TECHNICALMEMORANDUM

SUBJECT: Technical Comments on Bay-Delta Conservation Plan Modeling

SUBJECT: Technical Comments on the Bay Delta Conservation Plan/California Water Fix Partially Recirculated Draft EIR/Supplemental Draft EIS

Figure 25. EC in the Sacramento River at Rio Vista

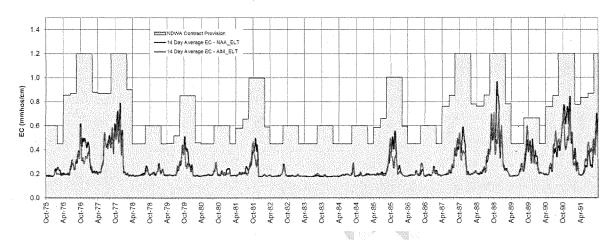
Although habitat areas are not clearly defined, the effects are observed at lower parts of the Delta system, such as the observations at Emmaton. Figure 26 illustrates an improvement in water quality in the Sacramento River at Rio Vista and at Three Mile Slough under Alt 4-ELT when compared to NAA-ELT. In Steamboat Slough at Sutter Slough, daily maximum, average, and minimum flows decrease under ALT 4-ELT as illustrated in Figure 27. As would be expected with decreased flows, decreases in stage also were also observed in Steamboat Slough, where daily average stage decreased by approximately 0.25 feet and the maximum stage is reduced on average by approximately 0.53 feet under Alt 4-ELT when compared to NAA-ELT. At the NBA pumping plant on Barker Slough daily maximum stage is decreased on average by approximately 0.6 feet, while daily minimum stage is increased on average by approximately 0.77 feet as illustrated in Figure 30. At RD 2068's pumping plant, daily maximum stage is reduced on average is increased on average by approximately 0.55 feet, while daily minimum stage is increased on average by approximately 0.57 feet as illustrated in Figure 31.

Figure 46. Daily Flow in North Fork Mokelumne River

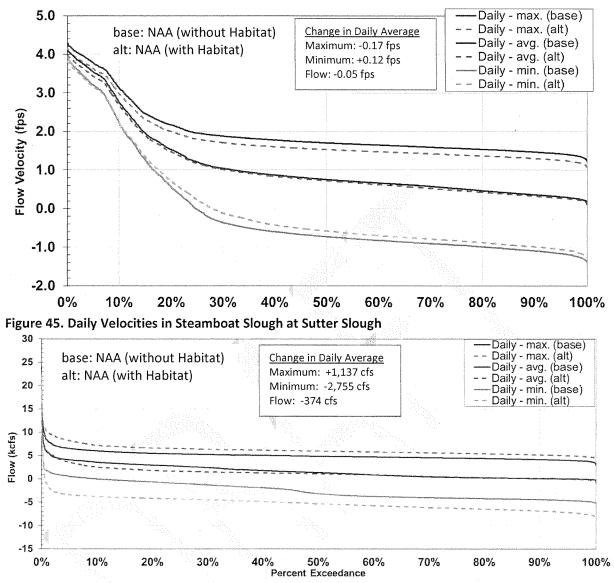
In the interior Delta, daily positive flow in the North Fork Mokelumne River increase on average by 1,137 cfs, while daily reverse flow increase on by 2,755 cfs as illustrated in Figure 46. Daily maximum stage decreases on average by approximately 0.72 feet while daily minimum stage increases on average by approximately 0.8 feet as illustrated on Figure 47. In Cache Slough at Ryer Island, daily maximum stage decrease on average by approximately 0.5 feet, while daily minimum stage increases by an average of approximately 0.5 feet. In Barker Slough at the NBA pumping plant daily maximum stage is reduced approximately 0.6 feet on average, while daily minimum stage is increased on average by approximately 0.76 feet as illustrated in Figure 50. At RD 2068's pumping plant, daily maximum stage is reduced on average by 0.52 feet, while daily minimum stage is increased on 3.56 feet as illustrated in Figure 51.

Figure 71. Daily Stage in Shag Slough at RD 2068 Intakes

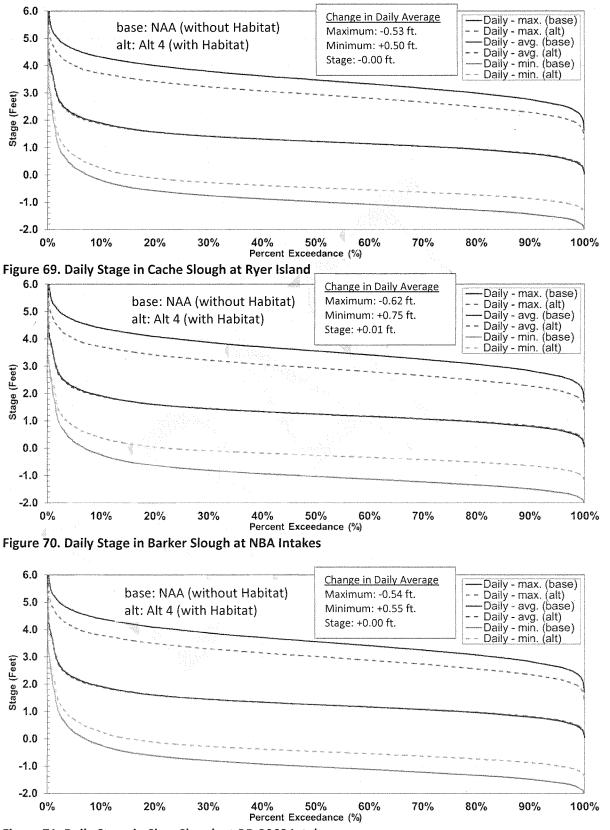
Figure 52 through Figure 71 compare the hydrodynamics and water quality under Alternative 4 with habitat and NAA without habitat. The effects are similar in pattern when compared to the models in support of the EIRS. In the Sacramento River at Emmaton and at Rio Vista, under Alt 4 with habitat, daily positive flows and daily reverse flows increase, while the daily average flows decrease when compared to NAA without habitat. Moreover, daily maximum stage decreases, while daily minimum stage increases when compared to NAA without habitat. At Emmaton, daily average flow decreases by approximately 1,800 cfs, daily average positive flows increase by 8,600 cfs, while daily average reverse flow increase by 7,460 cfs as illustrated in Figure 52. Daily maximum stage decreases by an average of 0.32 feet, while daily minimum stage increases by approximately 0.36 feet as illustrated in Figure 53. Figure 56 and Figure 58 illustrate worsening water quality in the Sacramento River at Rio Vista and at Three Mile Slough under Alt 4 with habitat when compared to NAA without habitat. In Steamboat Slough at Sutter Slough, daily maximum, average, and minimum flows decrease under ALT 4 with habitat as illustrated in Figure 63. Daily average stage is reduced by 0.29 feet, while daily maximum stage is reduced on average by 0.56 feet under Alt 4 with habitat when compared to NAA without habitat. In the interior Delta, daily positive flow in the North Fork Mokelumne River increase on average by 1,140 cfs, while daily reverse flow increases by 2,750 cfs as illustrated in Figure 66. Daily maximum stage decreases on average by approximately 0.72 feet while daily minimum stage increases on average by 0.8 feet as illustrated by Figure 67. In Cache Slough at Ryer Island, daily maximum stage decrease on average by ~0.53 feet, while daily minimum stage increase on average by ~0.5 feet. At the NBA pumping plant on Barker Slough daily maximum stage is reduced on average by ~0.62 feet, while daily minimum stage is increased on average by ~0.75 feet as illustrated in Figure 70. At RD 2068's pumping plant, daily maximum stage is reduced on average by ~0.54 feet, while daily minimum stage is increased on average by ~0.55 feet as illustrated in Figure 71.

Figure 91. Daily Stage in Shag Slough at RD 2068 Intakes

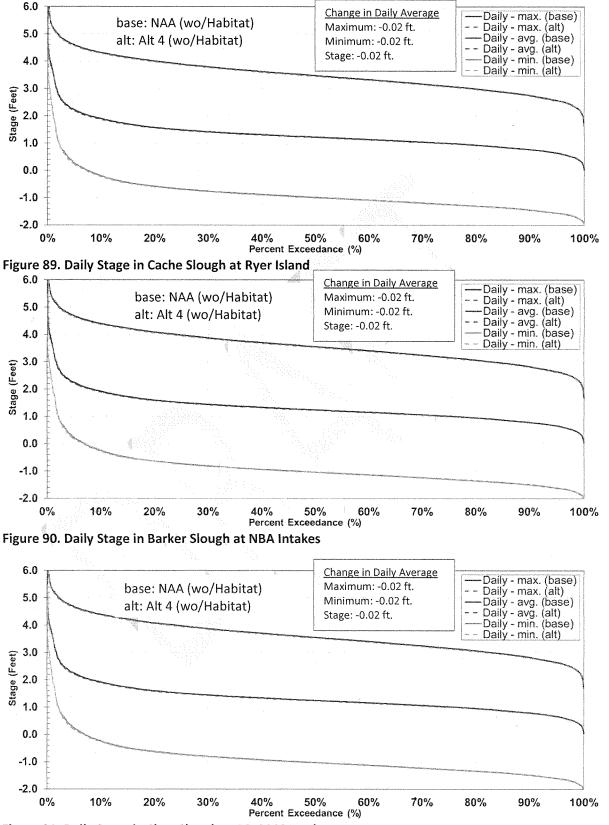
flows decrease under ALT 4 with habitat as illustrated in Figure 83. Daily average stage is reduced by ~0.21 feet and daily maximum stage is reduced on average by ~0.13 feet. Daily average stage is reduced by 0.21 feet under Alt 4 without habitat when compared to NAA without habitat. In the interior Delta, daily positive flow in the North Fork Mokelumne River decrease on average by 232 cfs, while daily reverse flow increase on by 297 cfs as illustrated in Figure 86. Changes in stage are immeasurable under Alt 4 without habitat as illustrated in Figure 87. Daily maximum, minimum and average stage in Cache Slough at Ryer Island, at the NBA pumping plant on Barker Slough, and at RD 2068's pumping plant decrease by 0.02 feet as illustrated in Figure 89, Figure 90, and Figure 91.
